17/6/19
OLIVIA
TYP. FLR PLAN

17/6/19 (2)
OLIVIA
TYP. FLR PLAN

17/6/19 (3)
OLIVIA
Text to become TYP-FFR
Highlight 3/4/7/10 Condition
Remove 1st level.

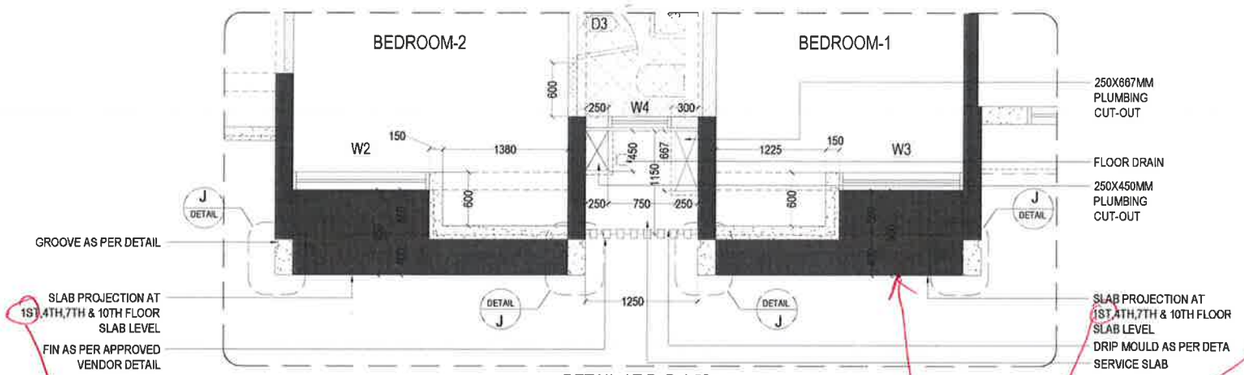
Part plan required.

Door Window Schedule is for 2nd floor. Please check It is also swapped for Doors & windows

Bldg Main Plan to be for Typical level. & Part plan to be for 4/3, 7 & 10th levels

DETAIL AT D @ 1:50
HORIZONTAL BAND ENLARGED DETAIL
[INTERNAL ROAD SIDE]

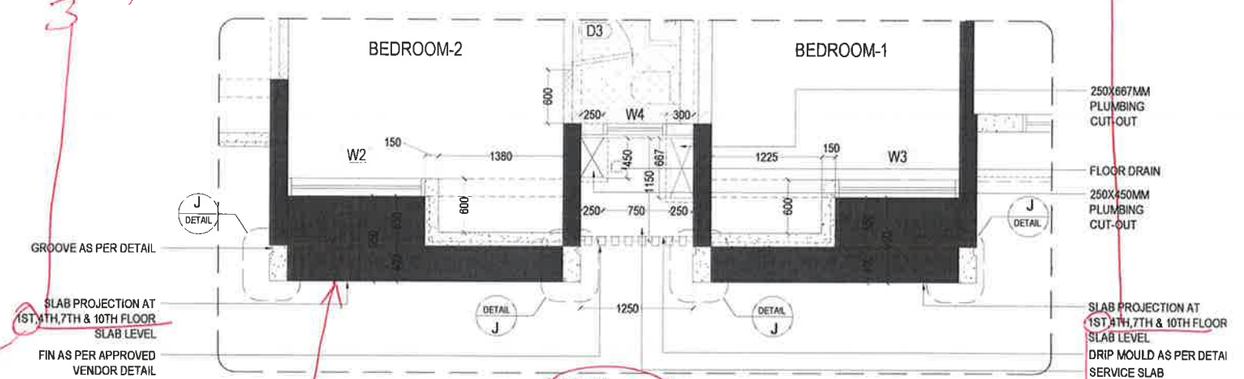
@ 4th, 7th & 10th level.

Do not mention 1st level.

3rd, 7th & 10th

Ideally Match on regd. But atleast differentiate..

To be Detail @ 'F'.
Has to be mirrored as per plan.

Do not mention 1st level.

WALL SECTION 01
WALL SECTION 02
WALL SECTION 03
WALL SECTION 04
WALL SECTION 05

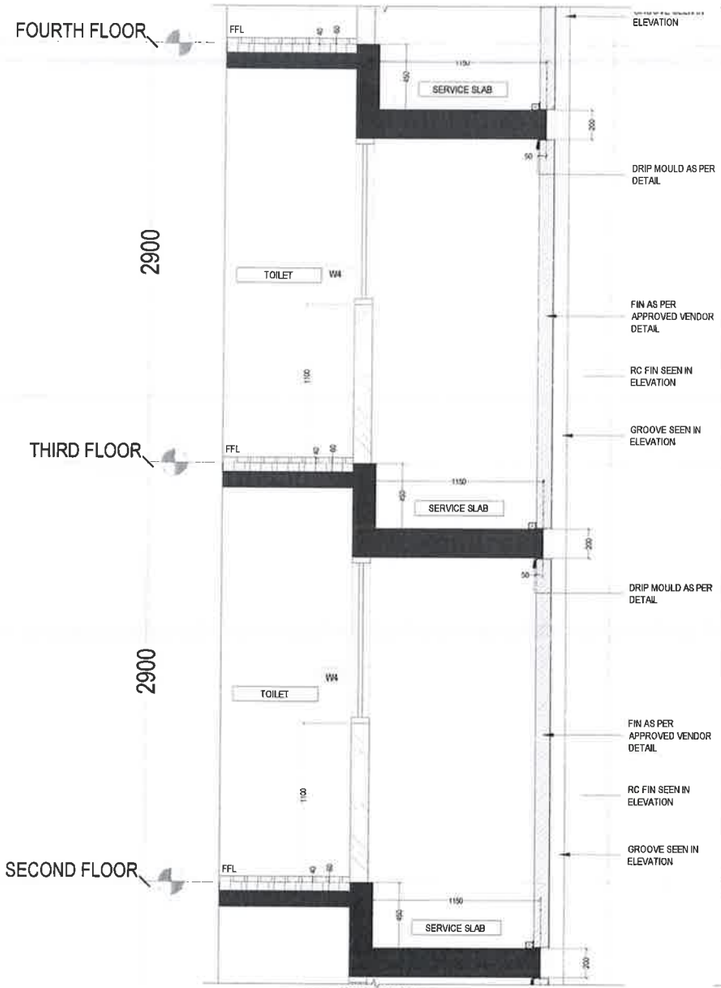
17/6/16.
OLIVIA
TYP. FLR
Levels
4/7/10?

This is wardrobe
Seen in elevation
as per section
line

WALL SECTION 12

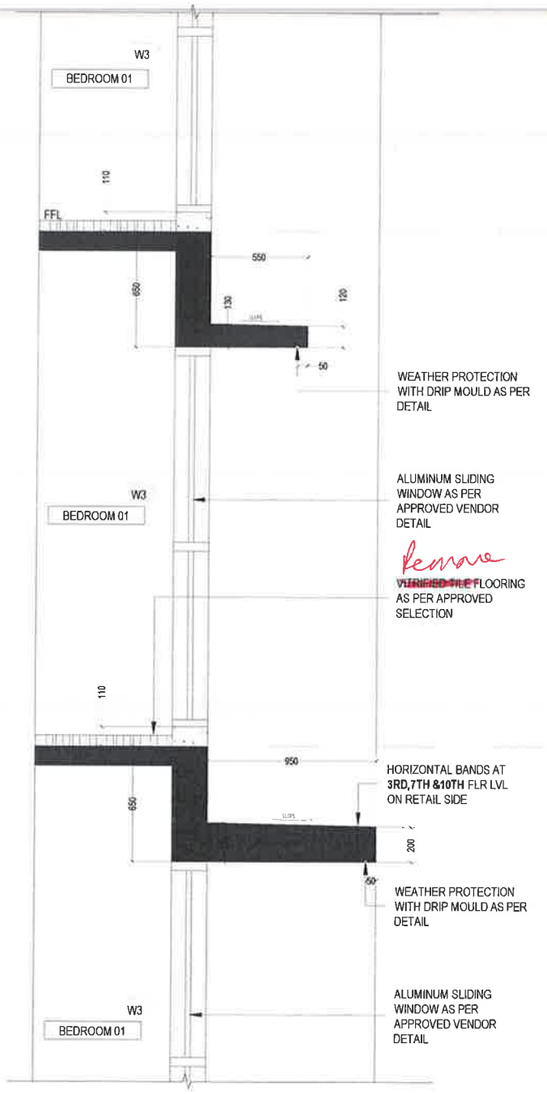
Why is hatch different??

WALL SECTION 04A

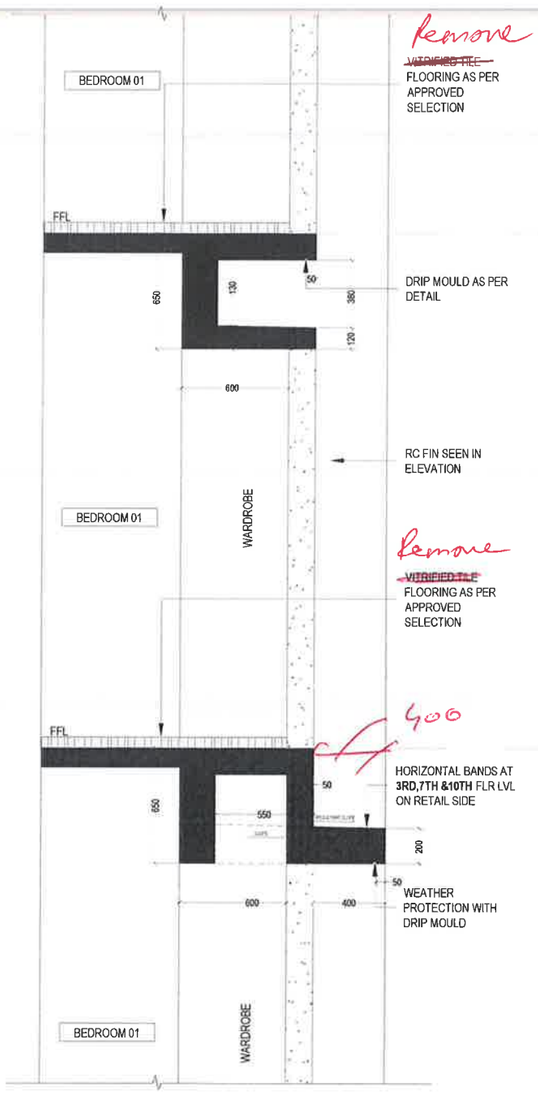
Section line to be marked in main plan.

WALL SECTION 07A

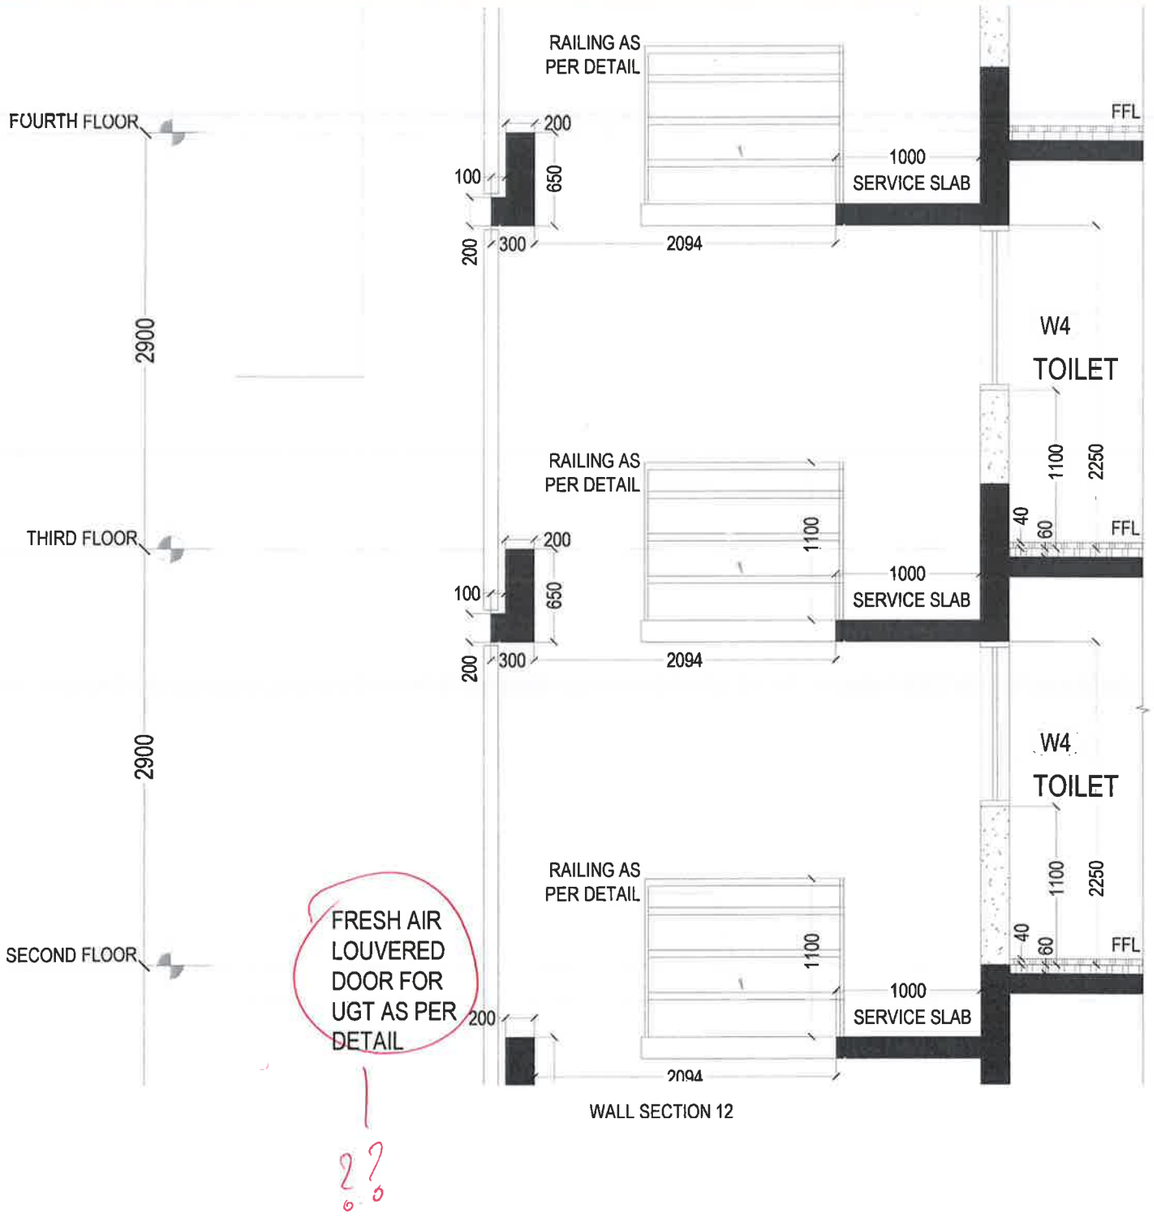
MENTION → ON Retail side below Section title.

L02-6A
↑
Section Missing
